**Technical Service Bulletin (TSB)**  
**Crank Gear Flange Dislocation**

<b>REFERENCE:</b>	<b>TSB:</b> 09-014-24 REV. A <b>GROUP:</b> 09 - Engine	<b>Date:</b>	September 27, 2024	<b>REVISION:</b>	09-014-24
<b>VEHICLES AFFECTED:</b>	<b>2023 - 2024 (H6) Jeep Meridian</b> <b>2023 - 2024 (M6) Jeep Compass</b> This bulletin applies to the following vehicles built on or after February 02, 2023 (MDH 0202XX) on or before February 24, 2024 (MDH 0224XX) equipped with a 2.0L I4 Turbo Diesel Engine With/ESS (Sales Code EBS).	<b>MARKET APPLICABILITY:</b>			
		<input type="checkbox"/> NA <input type="checkbox"/> MEA <input type="checkbox"/> SA <input checked="" type="checkbox"/> IAP <input type="checkbox"/> EE <input type="checkbox"/> CH			
<b>CUSTOMER SYMPTOM:</b>	<b>Customers may experience one or more of the following:</b> <ul style="list-style-type: none"> <li>• Vehicle does not start due to crank gear flanged dislocated.</li> <li>• Abnormal noise from the engine compartment.</li> <li>• Noise from the timing cover area.</li> </ul>

This bulletin supersedes Technical Service Bulletin (TSB) 09-014-24, date of issue May 18, 2024, which should be removed from your files. All revisions are highli

**Fig. 2**  
Mounting Bolt

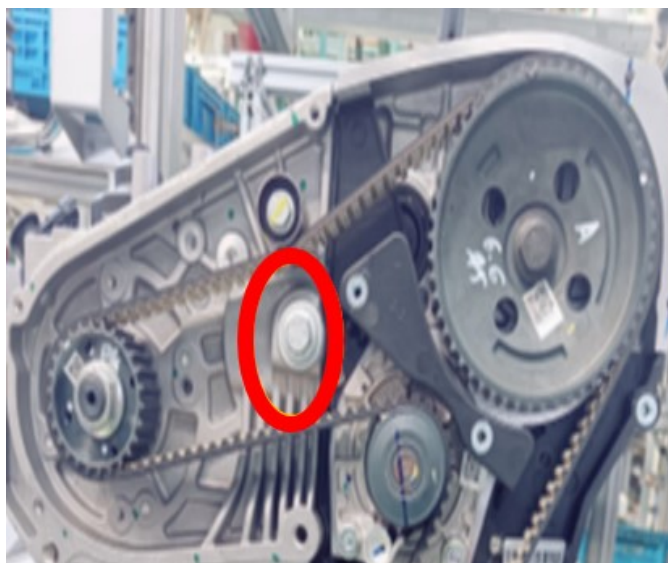
4. Remove the mounting bolt [Fig. 2](#).
